## Supporting document for Comment 109, for D0.2.

### Specifications (for Table 68-4)

Test figure (for subclause 68.6.4)

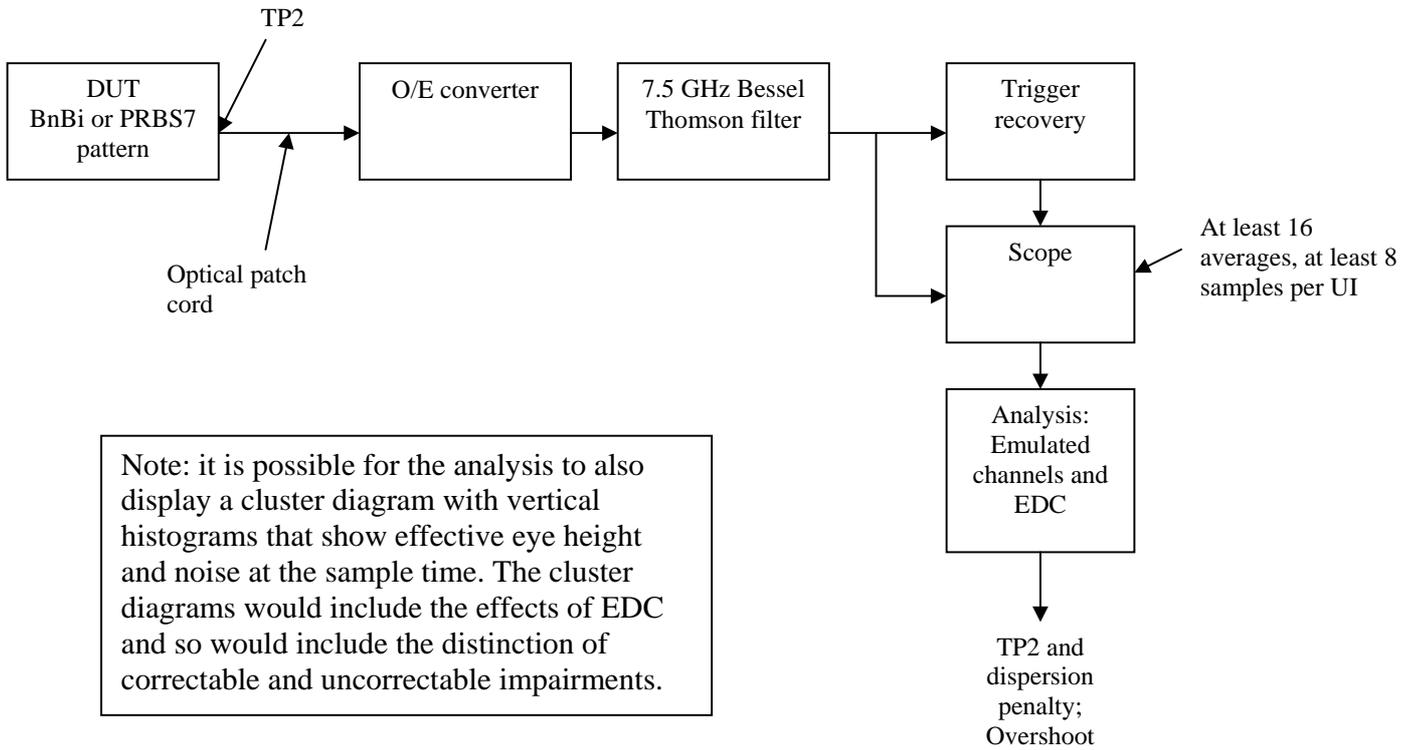
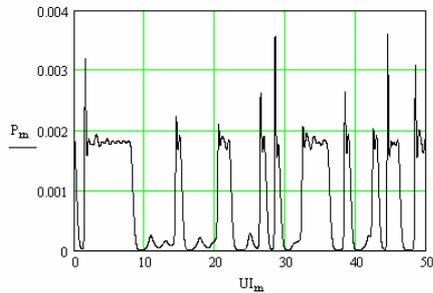
The TP2 and dispersion penalty is intended to control deterministic dispersion. A waveform from TP2 of the DUT is to be captured on an oscilloscope for analysis to determine if its performance, when operating in conjunction with fibers expected in the application, is within acceptable penalty bounds.

The DUT shall repetitively transmit the BnBi data pattern, as defined in clause 52 [subclause], or a PRBS7 data pattern through a test patchcord into an O/E converter and through a 7.5 GHz Bessel Thomson filter. The filter output data should then run into the oscilloscope and also into a trigger recovery circuit. The trigger recovery circuit must recover a suitable pattern and/or clock trigger for the scope so that the waveform can be captured and stored. Averaging of at least 16 waveforms, or equivalent, is required. An effective sample rate of at least 8 samples per unit interval is required. If the BnBi pattern is transmitted, then the specific sub-pattern [TBD] is to be recorded. If PRBS7 is used, then the entire pattern is to be recorded. The DUT must be fully operational in both transmit and receive directions during this test.

The stored waveform is to be analyzed in combination with emulated fibers and an emulated reference EDC circuit. The emulated fibers shall be identical to the ISI generators used in the TP3 Static Stressed Receiver Sensitivity Test [TBD] as described in subclause 68.6.5.1, except that they are emulated as MATLAB software models in this test. The reference EDC emulator is defined as [TBD, MATLAB, but based on PIE-D or equivalent].

The waveform is also measured for overshoot at both logic levels. Overshoot is evaluated at the output of the filter, before the effects of channel or ref receiver emulation.

Test figure (for subclause 68.6.4)

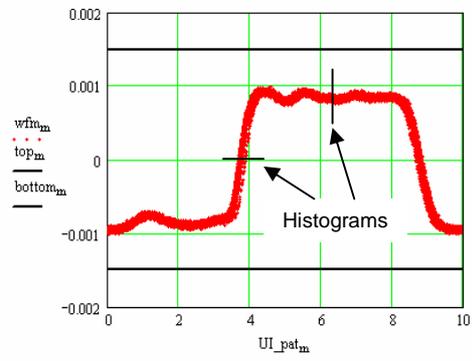
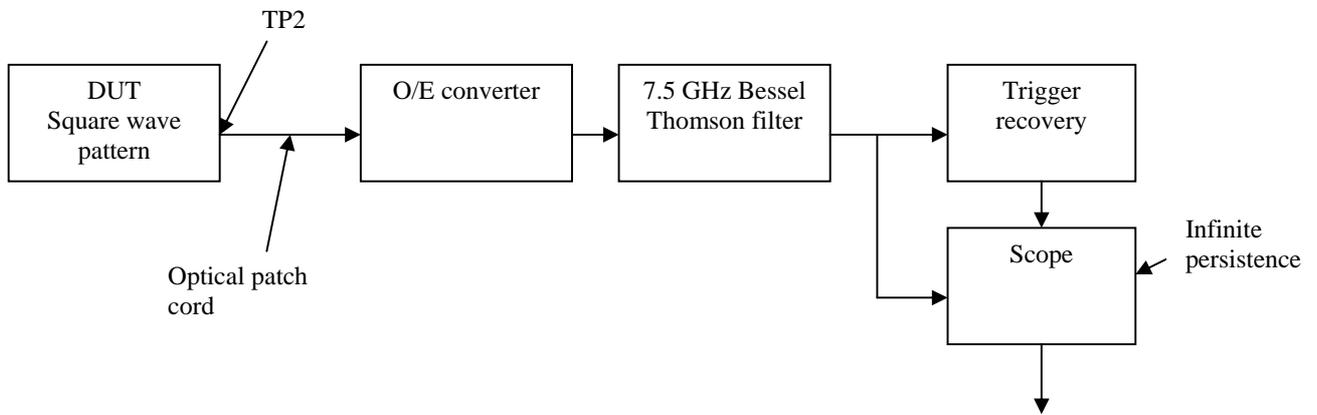
The optical SNR and jitter measurements are intended to control uncorrelated noise and jitter.

The DUT shall repetitively transmit the low frequency square pattern, as defined in clause 59 [subclause], through a test patchcord into an O/E converter and through a 7.5 GHz Bessel Thomson filter. The filter output data should then run into the oscilloscope and also into a trigger recovery circuit. The trigger recovery circuit must recover a suitable pattern and/or clock trigger for the scope so that the waveform can be displayed. The scope should be run in infinite persistence mode. The DUT must be fully operational in both transmit and receive directions during this test.

A vertical histogram with width of 0.01 UI is used to measure amplitude noise. It should be approximately centered in the upper portion of the square wave. A horizontal histogram with width of ~0.01 OMA is used to measure jitter. It should be placed approximately at the average amplitude value of the square wave. At least 1000 hits are required in each histogram. Compensation for measurement equipment noise and jitter is allowed [explain]. Note that these methods are similar to those used to calibrate the amplitude and jitter used in the Static Stress Receiver Sensitivity Test for TP3 [note to editor – perhaps they can be combined into one piece of text].
